LOCA & SEISMIC ANALYSIS

CUSTOMER: Texas Utilities Generating Company

UNIT: Comanche Peak Steam Electric Station  
Units 1 & 2

REPORT NO.: 34977SL-001

Figure 2

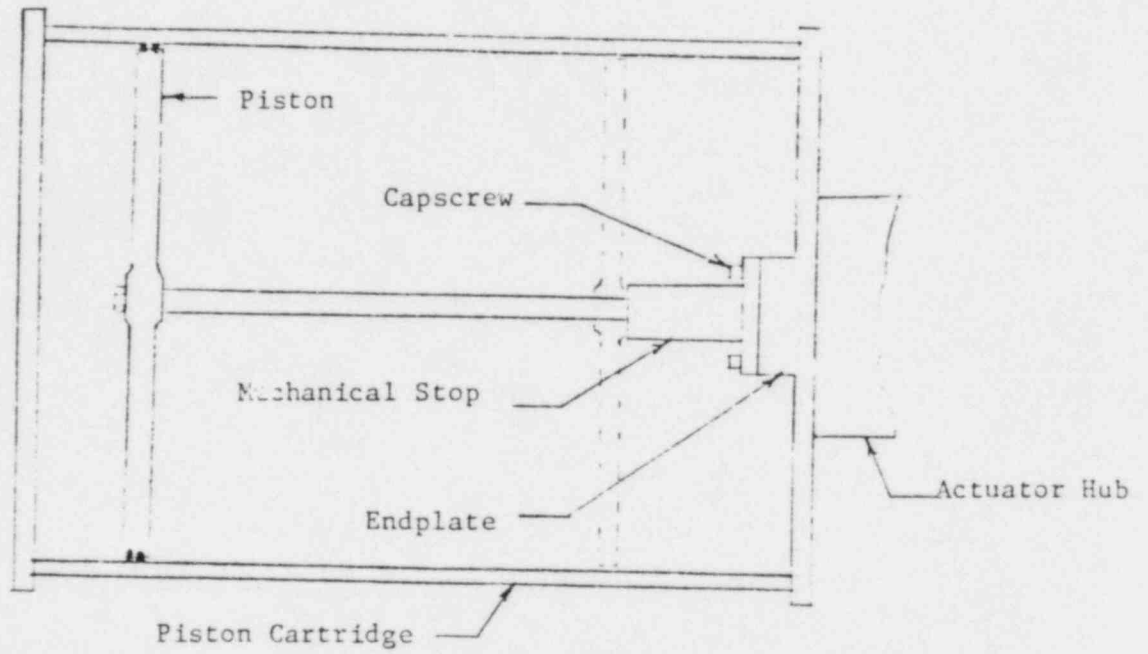
Based on the results of this analysis Fosi-Seal recommends that the amount of valve opening for all the subject valves be restricted to 65 degrees. This can be accomplished by bolting a stop to the internals of the Matryx piston cartridge which would limit the stroke of the actuator. See Figure 2 on Page 9.
